ASPEN HISTORIC PRESERVATION COMMISSION

August 7, 2024

XIV.A **325 W. Hopkins Ave.** - Conceptual Major Development, Relocation, and Variations Review - **Public Hearing**

Staff Recommendation: Staff recommends continuation of the conceptual major development review of 325 W. Hopkins Ave.

Sheet No.
A1.02

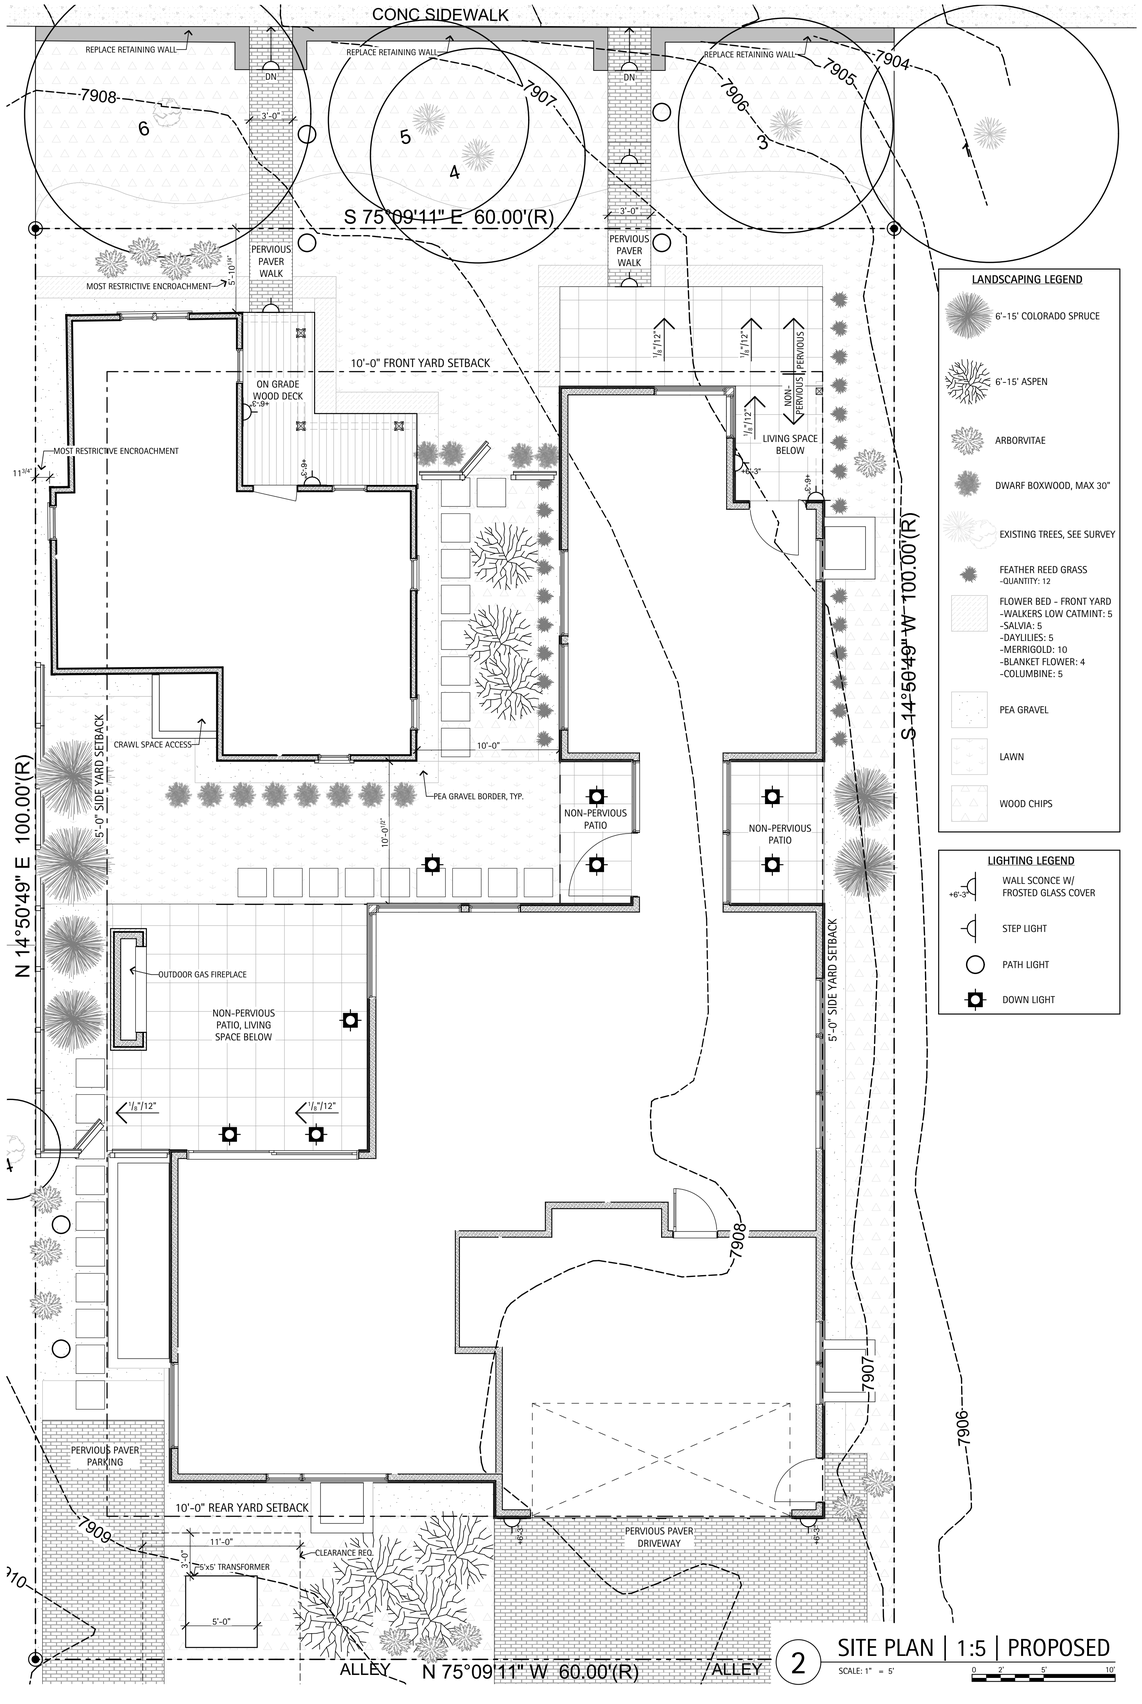
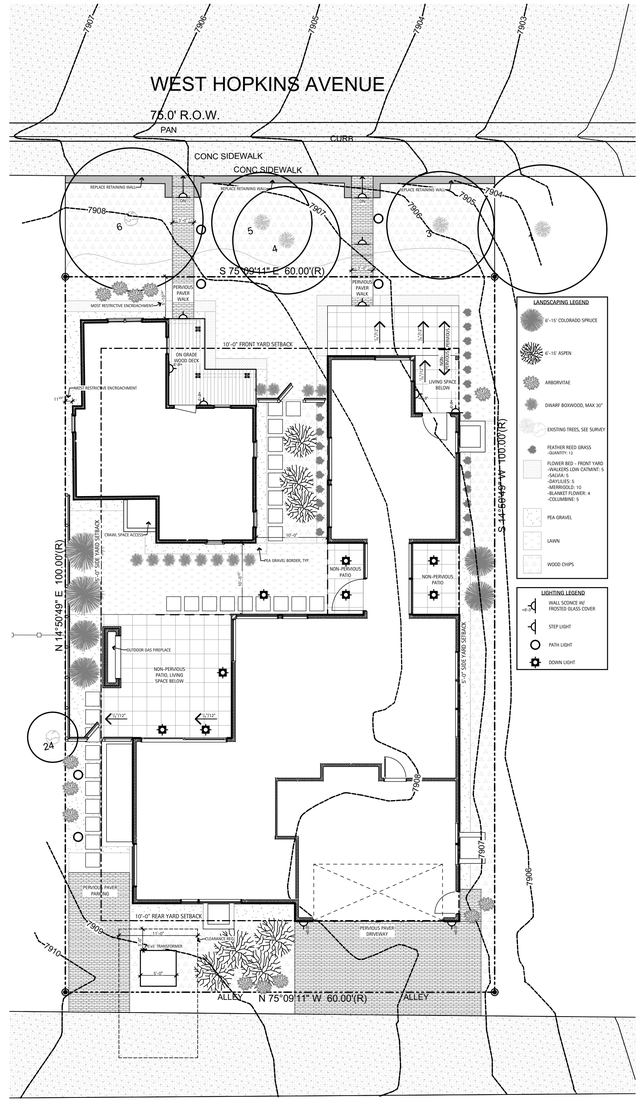
- Figure 2 of Exhibit A.1 differs from the Site Plan on Sheet No. A1.02 of Exhibit L.1.

Sheet No.
A2.01

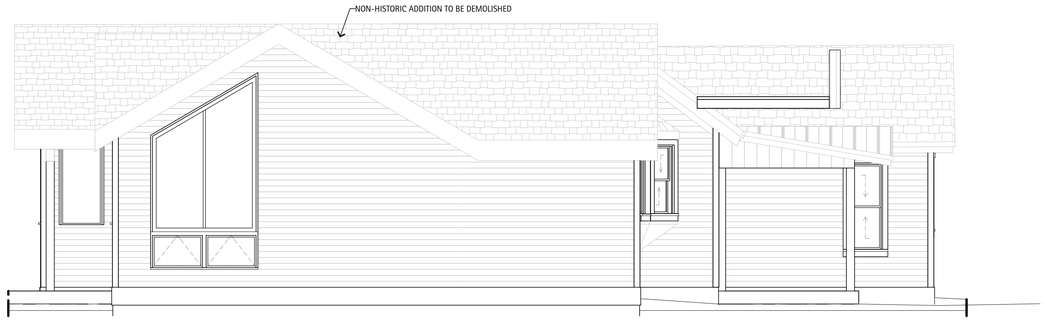
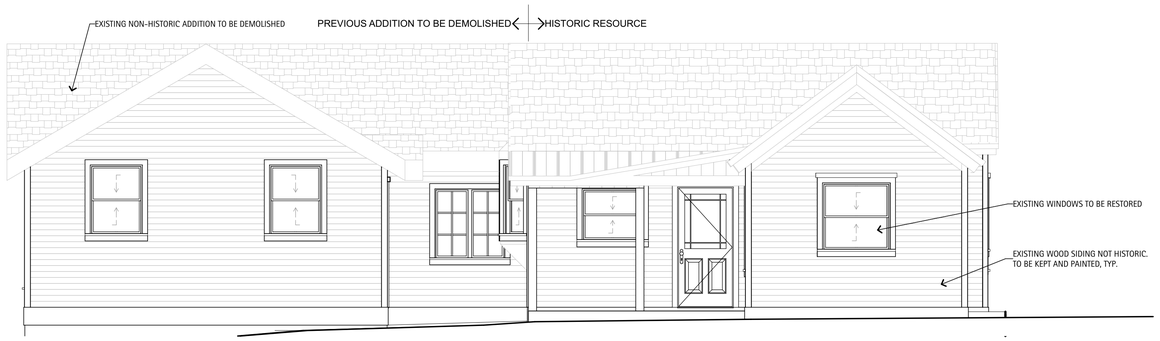
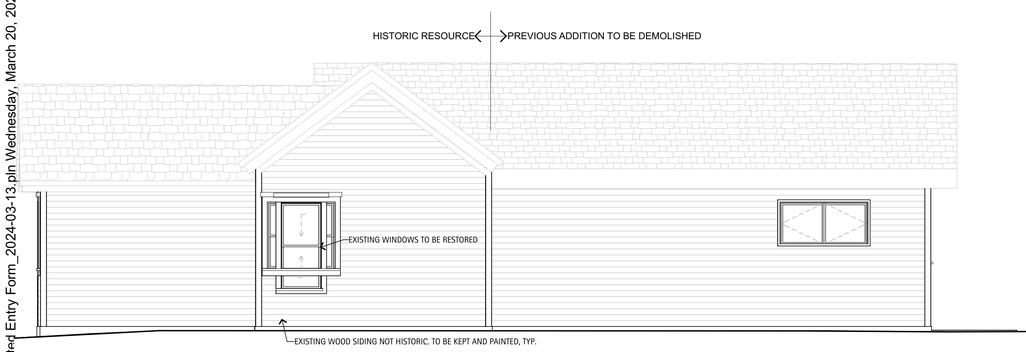
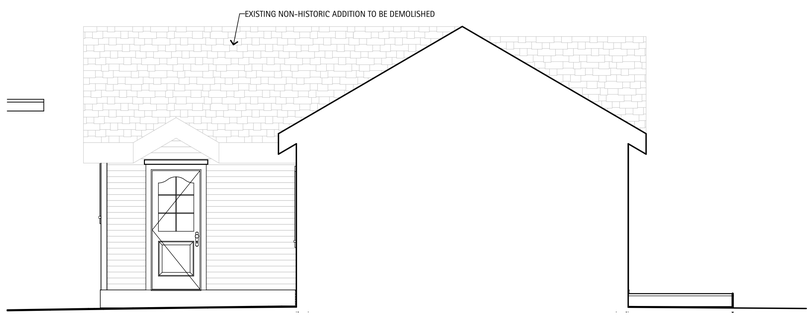
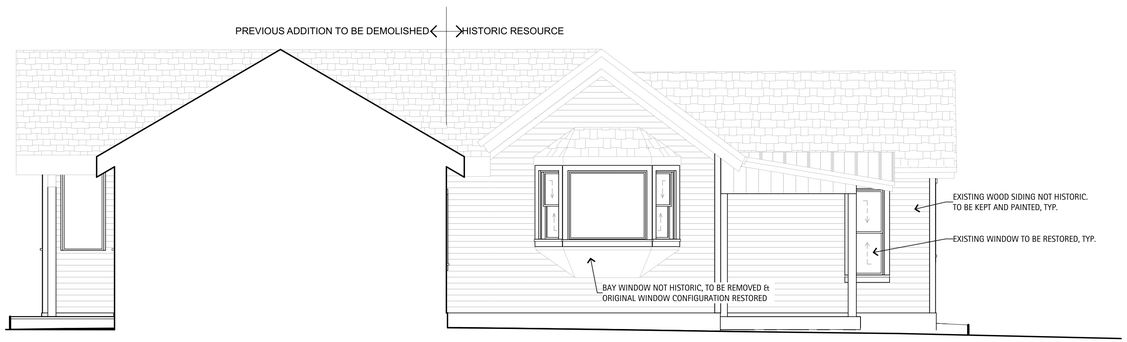
- Please clarify the size and location of the window on west façade of the historic resource. Sheet No. A2.01 is unclear.

Sheet No.
A2.02

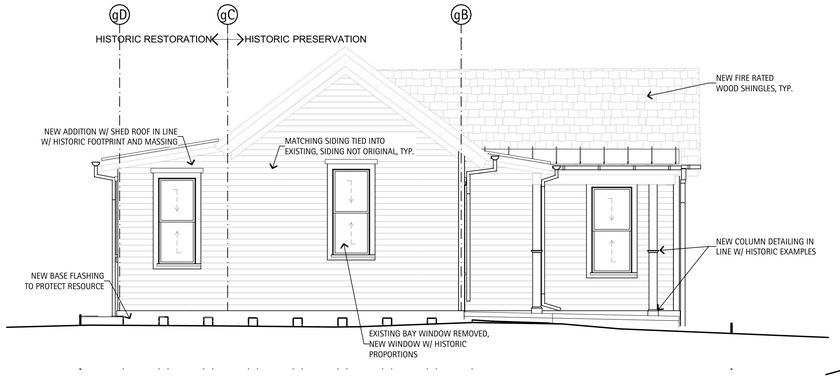
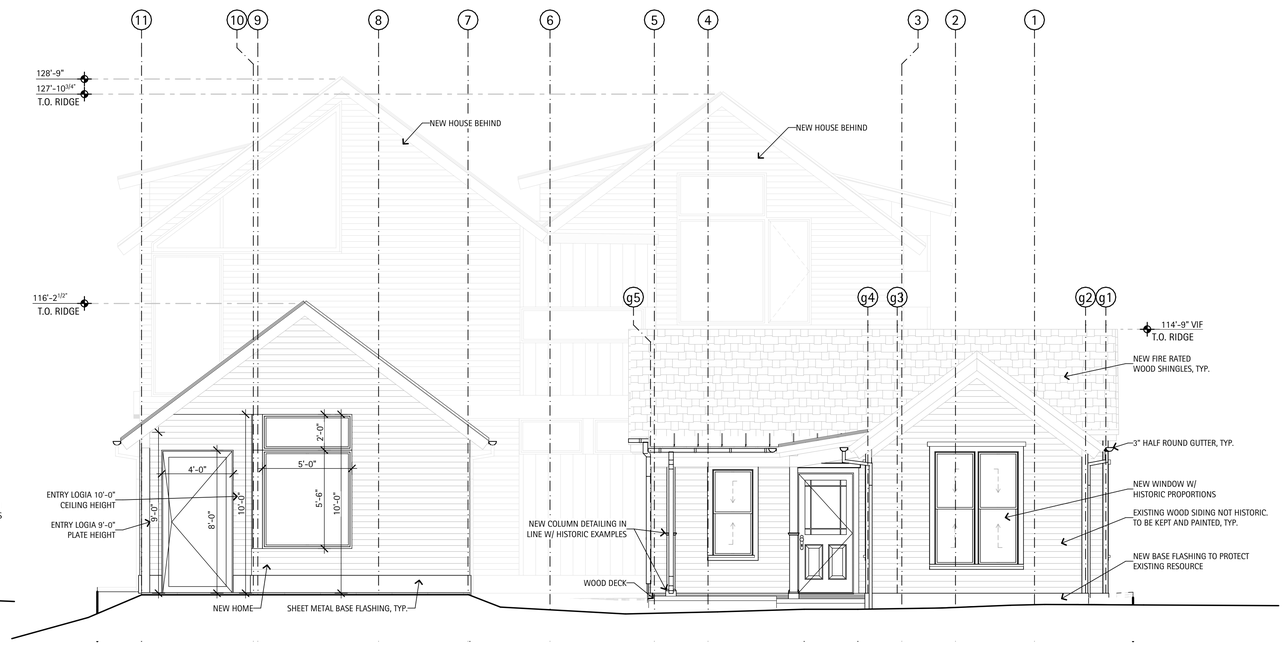
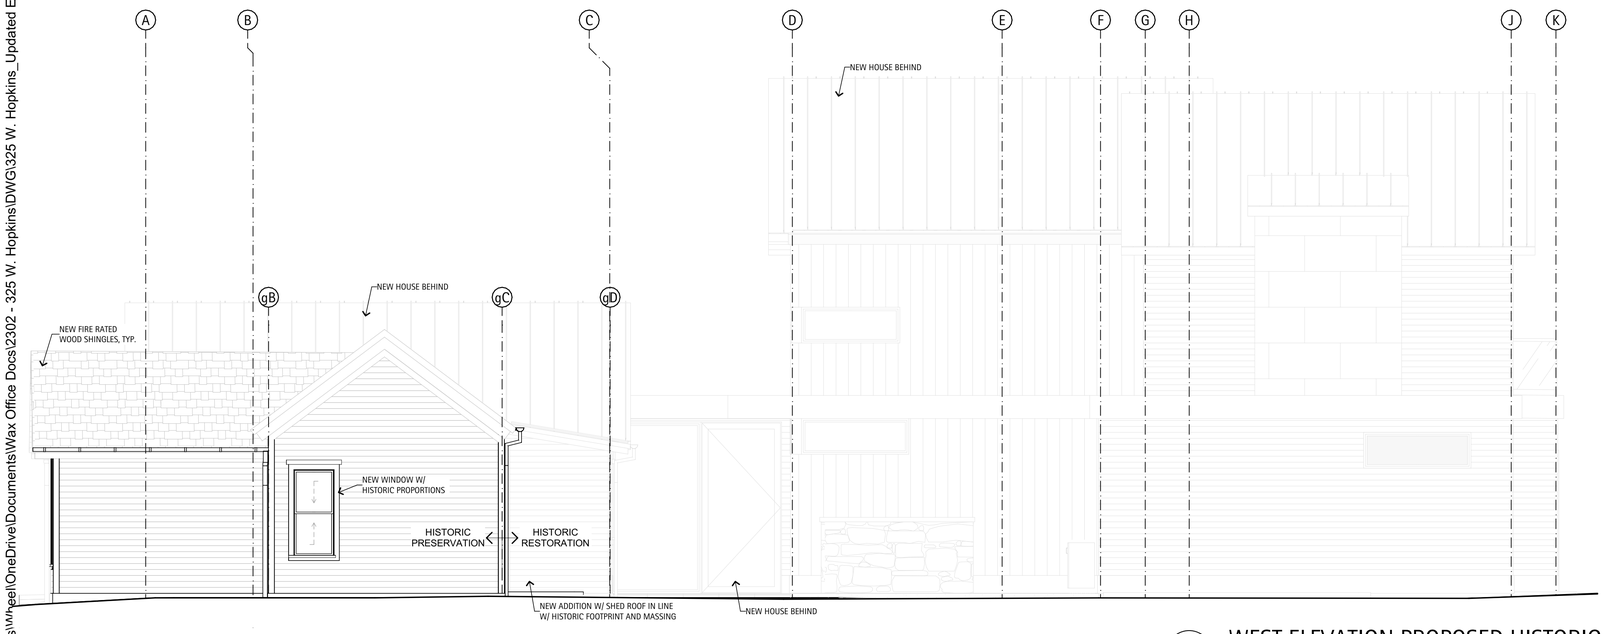
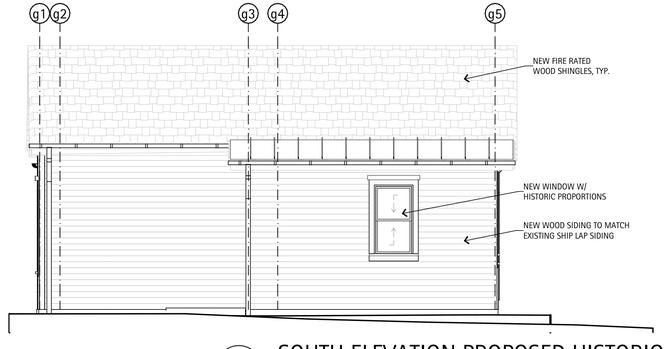
- A conceptual drainage plan is not included in the application. As drawn in the north elevation on Sheet No. A2.02, regrading around the new construction slopes toward the historic resource. As this condition does not meet Guideline 1.8, additional information and/or a redesign is required.

- As depicted in elevation on Sheet No. A2.02, the topography of the north side of the site is proposed to change substantially (more than 2 feet above existing conditions at the proposed northeast corner of the new building). Re-grading the site in a manner that changes historic grade is generally not allowed per Guideline 1.23.

- Please clarify whether the existing windows on the historic resource are to be restored as indicated on Sheet No. A2.01 or removed and replaced by new windows with historic proportions as indicated on Sheet No. A2.02.

Figure 2: Existing front window (left) and historic photograph of two double hung windows (right)

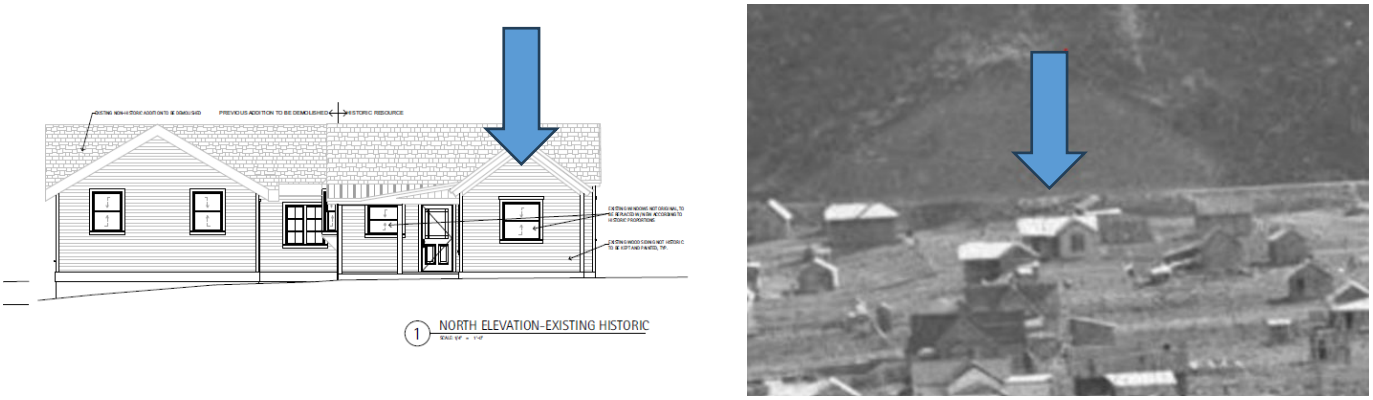
- Please clarify the size and location of the window on west façade of the historic resource. Sheet No. A2.01 is unclear.

Sheet No. A2.01 is revised to include dimensions. A photograph of the window in question is included to demonstrate it is not historic. Inspection of framing during demolition may result in adjustment to the proposed window. The intent of this project is to restore the landmark, so any historic framing discovered during demolition may alter the proposed window sizes and locations.
